HISTORIC PRESERVATION REVIEW BOARD STAFF REPORT AND RECOMMENDATION

Landmark/District: Address:	Georgetown Historic District 3417, 3419 and 3421 Q Street NW	(x) Consent
Meeting Date: Case Number:	June 30, 2022 22-296	(x) Subdivision(x) Alteration(x) Permit

Left: The lots to be combined are indicated within the red boundary. Below: The facades of 3419 and 3421 Q Street.

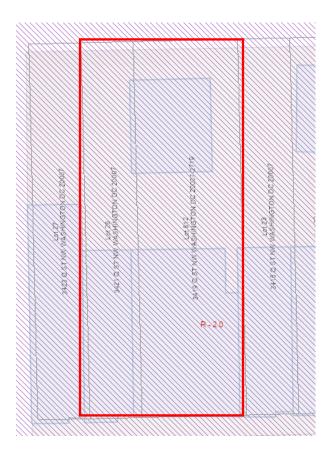
The proposed exterior work is minor, a second-story roof deck at rear, extending across the party wall of the two buildings and entailing the demolition of a low parapet at the property line. The nature and extent of the work is what would normally be reviewed by HPO staff. In this case, it is currently under review by the Old Georgetown Board of the U.S. Commission of Fine Arts.

The interior demolition is limited and appears reasonable. It is true that more demolition could be proposed in the future, and the combination of the buildings could induce future additions or exterior alterations to the properties, but these will be subject to Commission and Board review.

HPO recommends that the Board recommend approval of a permit for the connection of 3419 and 3421 Q Street and the construction of a roof deck, as well as approve the concept of subdivision to implement the project.
